City of Santa Barbara California

PLANNING COMMISSION STAFF MEMO

SUBJECT: 825 De la Vina Street (MST2007-00400)

Scale: 1/8" = 1'-0"
 Date: 10/10/00
 Drawn: J. L. R. FOR PC
 825 De La Vina
 Santa Barbara
 California
 Drawing: EXTERIOR ELEVATIONS
 A3.2

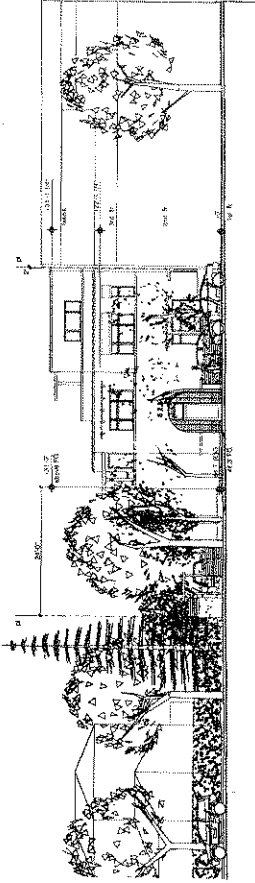
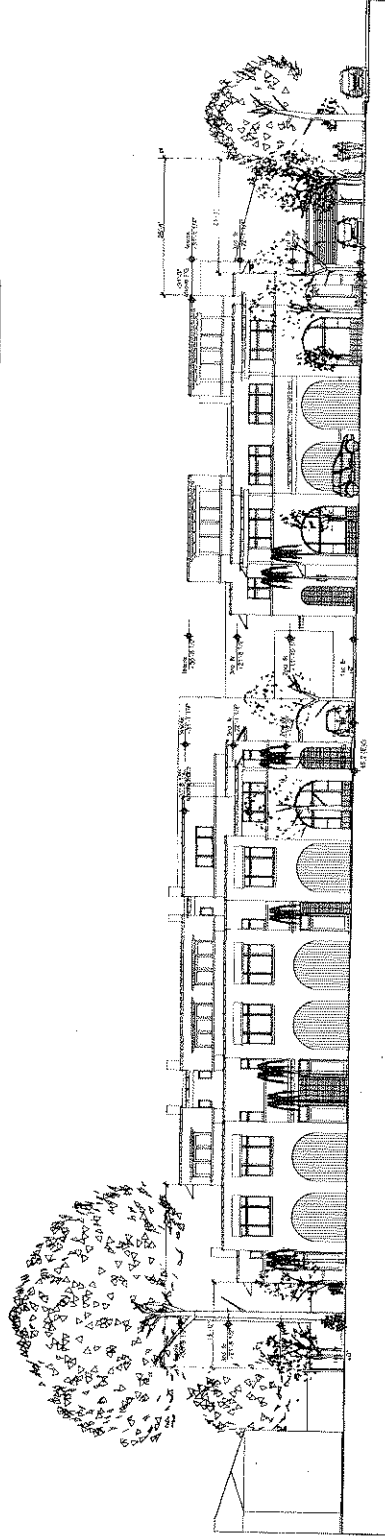
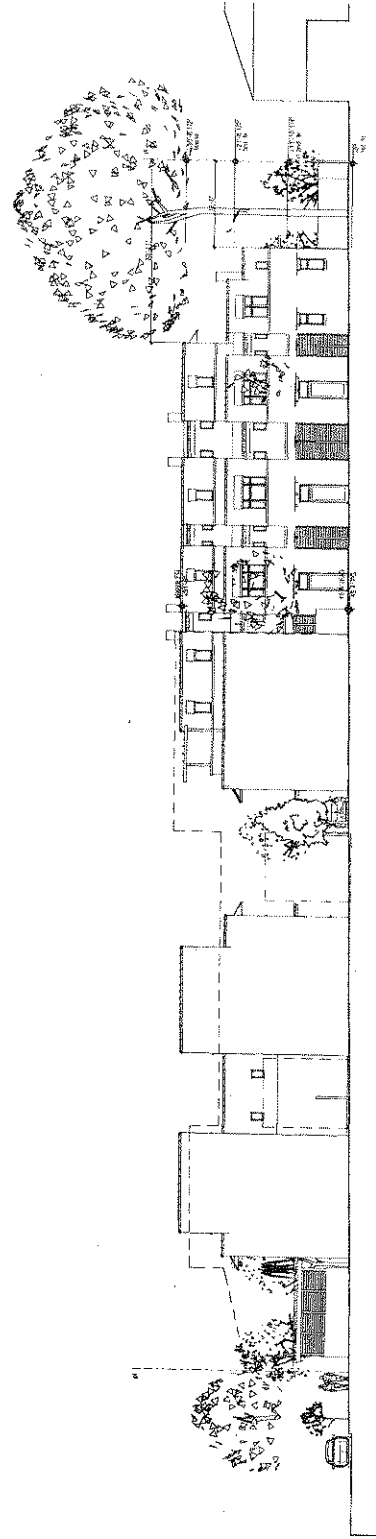
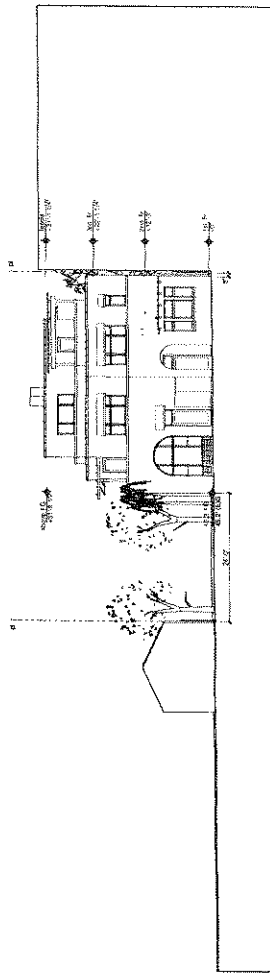
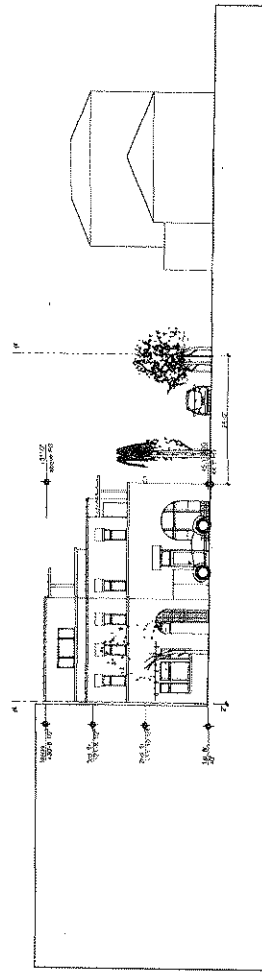
As directed by the ABR the roof overhangs and pitched roof sections have been eliminated and the trellises at the third floor and East elevation have been reduced in size. The North and West elevations were redesigned as suggested by ABR to better integrate into the overall design. As a result the projecting second floor bays were eliminated and additional breaks, windows and relief were added on the North facade. Per the ABR additional scale giving elements and details such as trellises, awnings, moldings and trim were added. Key elevation walls were thickened to add shadow and mass. A central mailbox location has been added at the pedestrian entry. The scale of the permeable paving pattern of the auto court was reduced to a smaller scale pattern as directed by the ABR.

With input from the neighbors the West elevation was revised to include additional architectural details such as lattices, trellises and awnings. Neighbor input on the landscape design resulted in revisions to the plant selections along the South and West property lines to include the use of more palm species in these areas.
